SUBJECT: RADIATOR COOLING FAN MOTOR
VEHICLES: 365 GT4 2+2, 365 GT 2+2, 365 GTB4 & 365 GTC 4

PARTS INFORMATION:

FIG. A
 SOLUZIONE ESISTENTE
 ORIGINAL FITTING

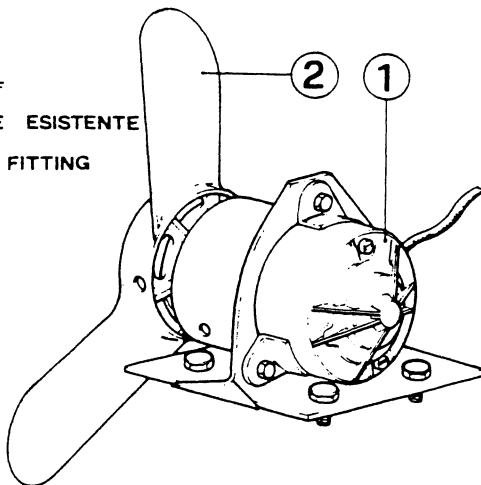
A new Lucas cooling fan motor P.N. 107429 is now available since the previously used Marelli fan motor P.N. 102029 is no longer in production. The new motor can be adapted to the existing fitting through a proper clamp (see Fig. B.). It is recommended to position the new fan in the same place as the old one.
